Suite 609

*** SUITE 609 * (INVENTORY SUITE)**

**SUITES 609 - NOYAC BAY (inventory suite)**

■ Royal Pine Homes ■ 25 Baker Hill Blvd -- Stouffville, ON ■ Apr 04, 2018

NEW PLAN

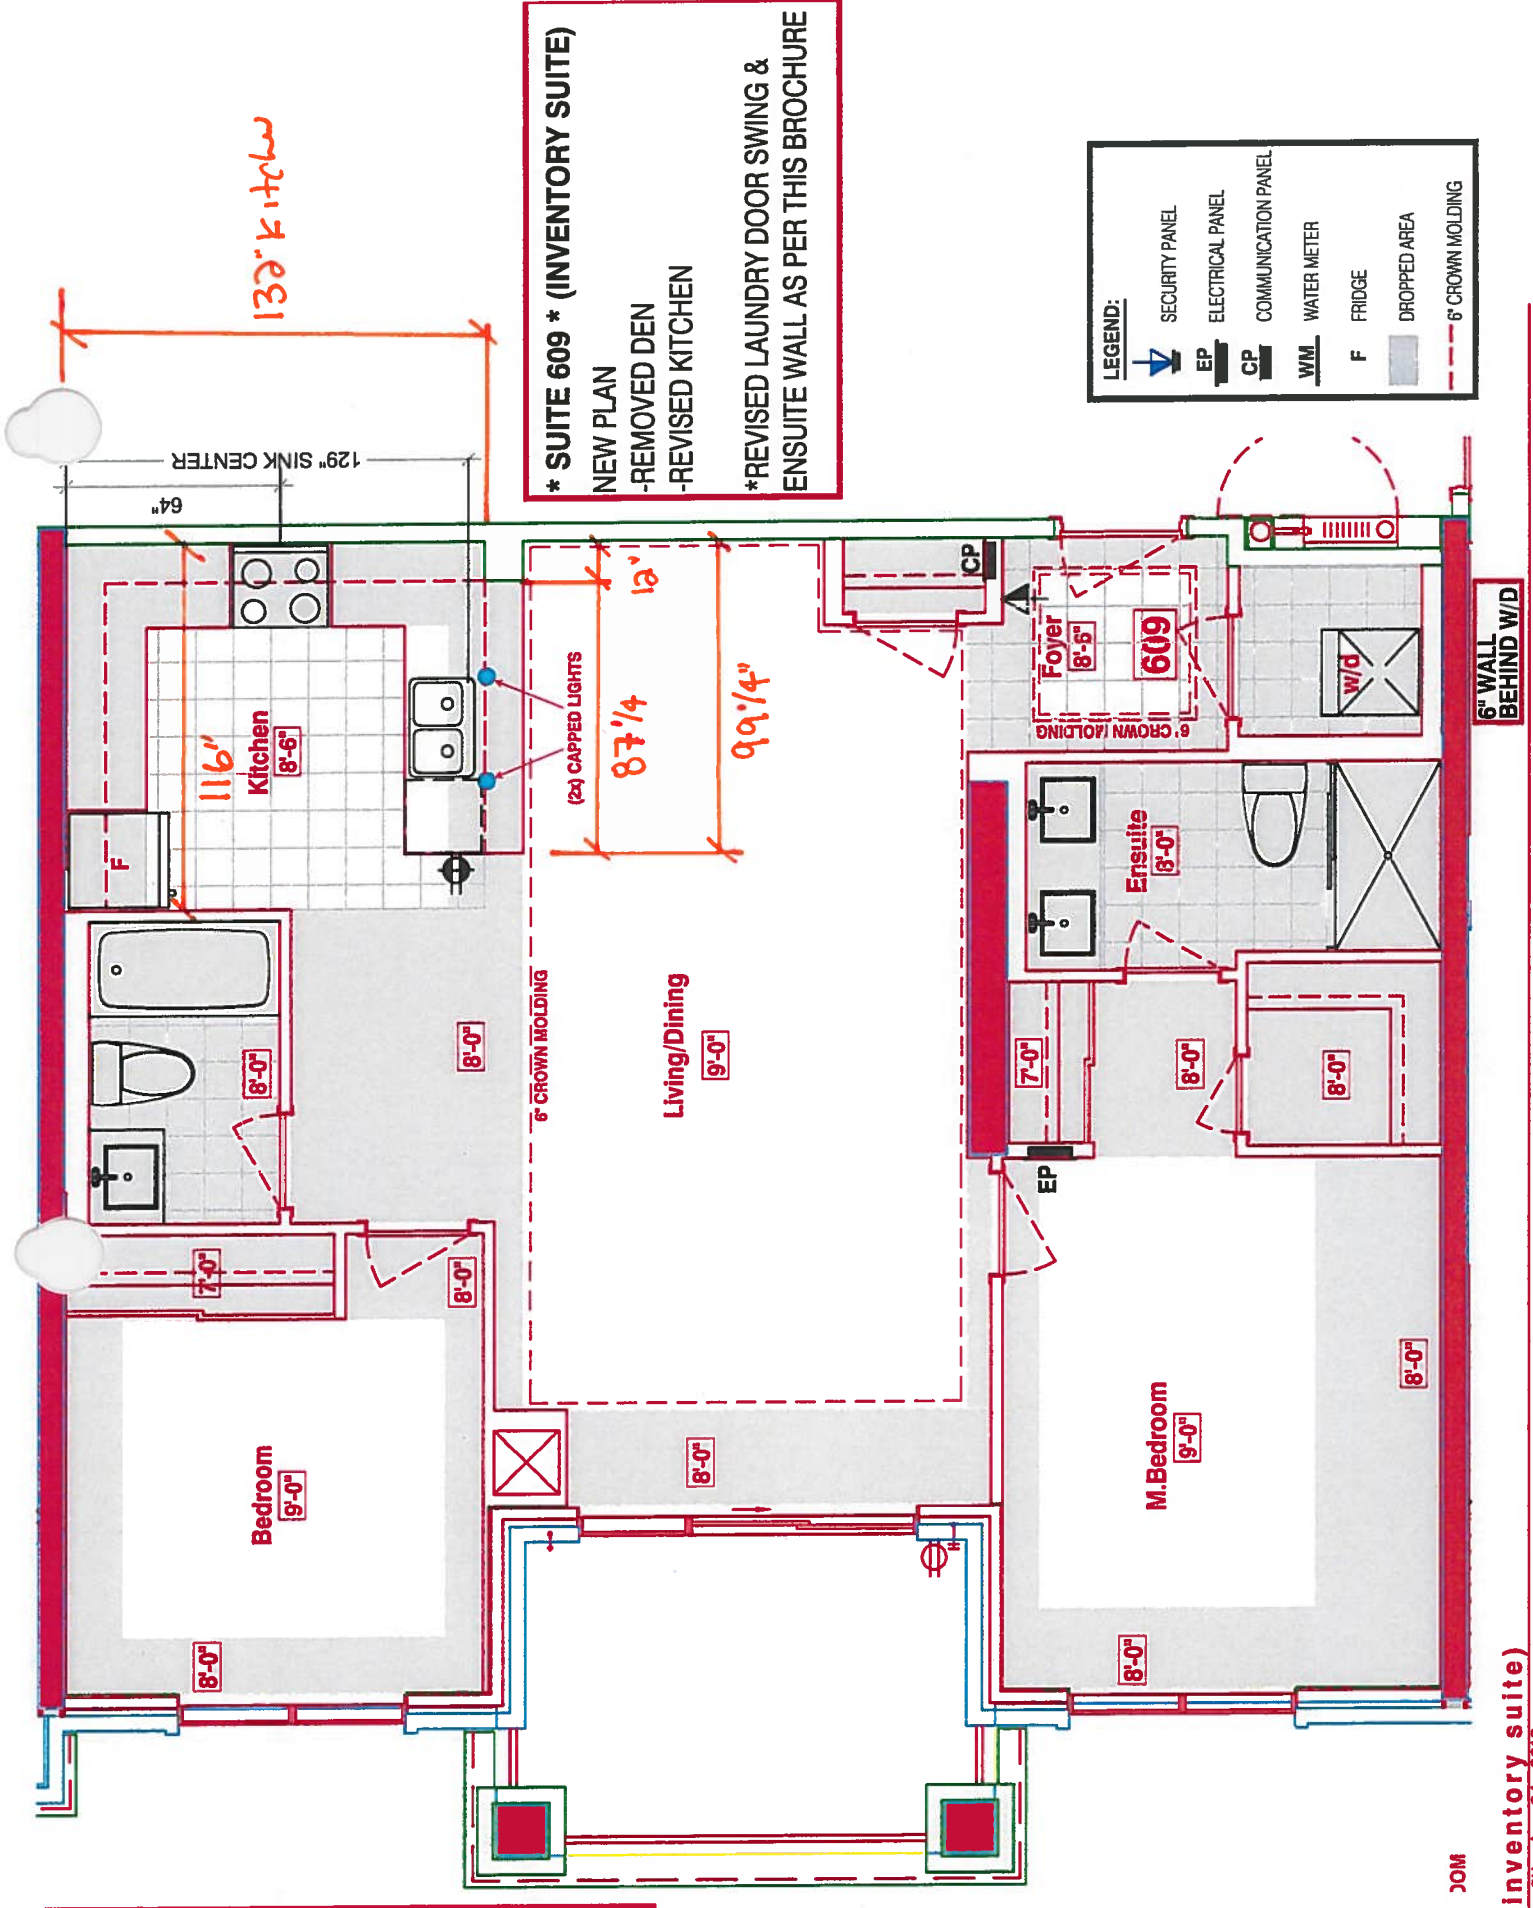
-REMOVED DEN

-REVISED KITCHEN

***REVISED LAUNDRY DOOR SWING & ENSUITE WALL AS PER THIS BROCHURE**

609-Inventory Suite

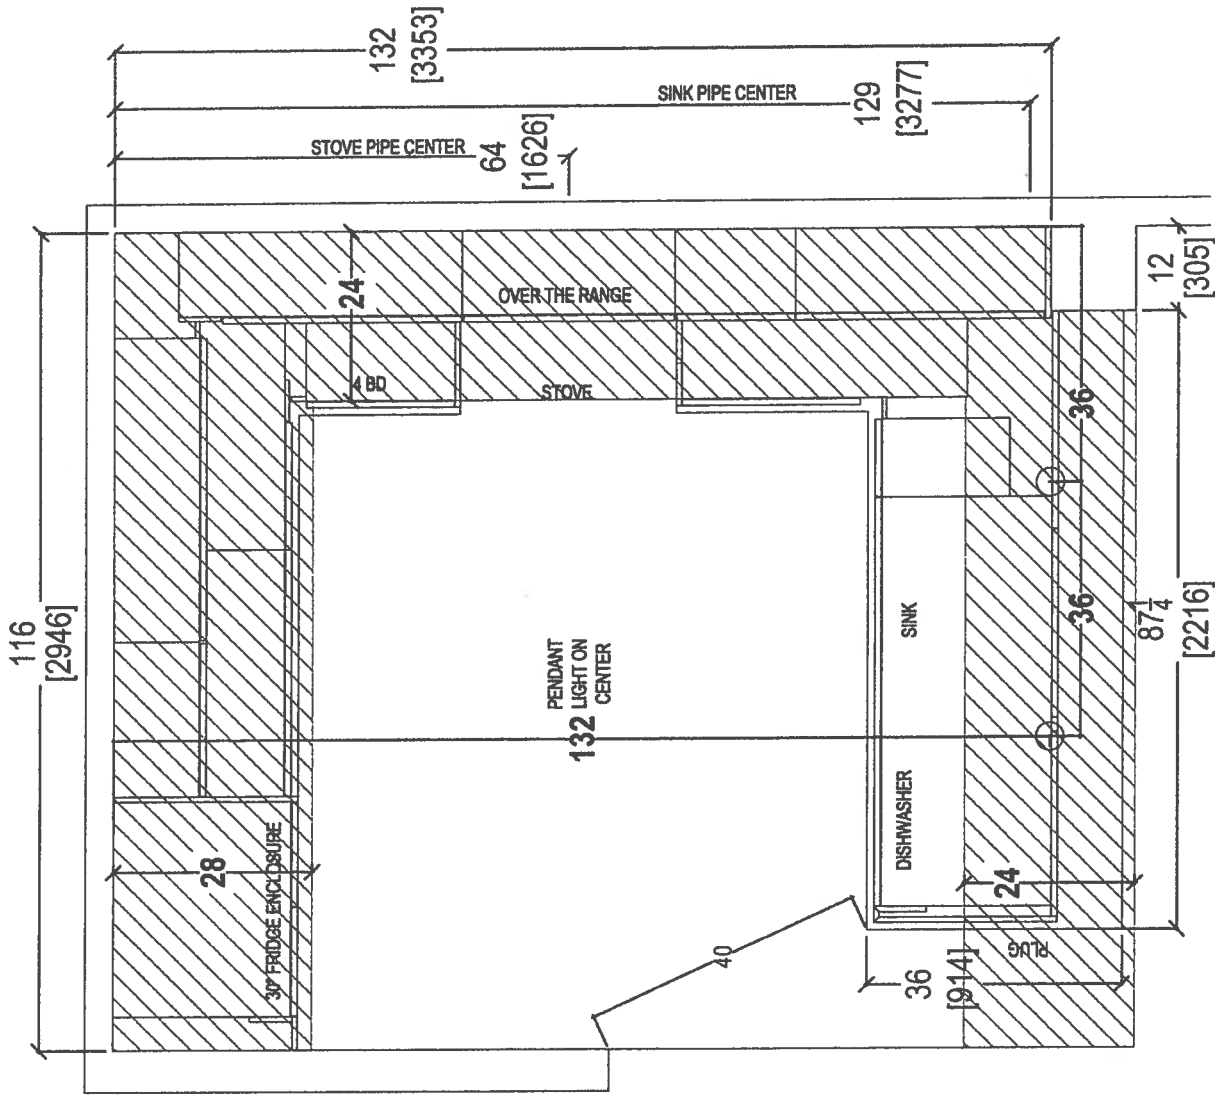
- STD KITCHEN LAYOUT
- STD APPLIANCES PKG
- (1x) = Plug, Peninsula
- (5x) = Plug Lights
- (2x) = Pendant Lights
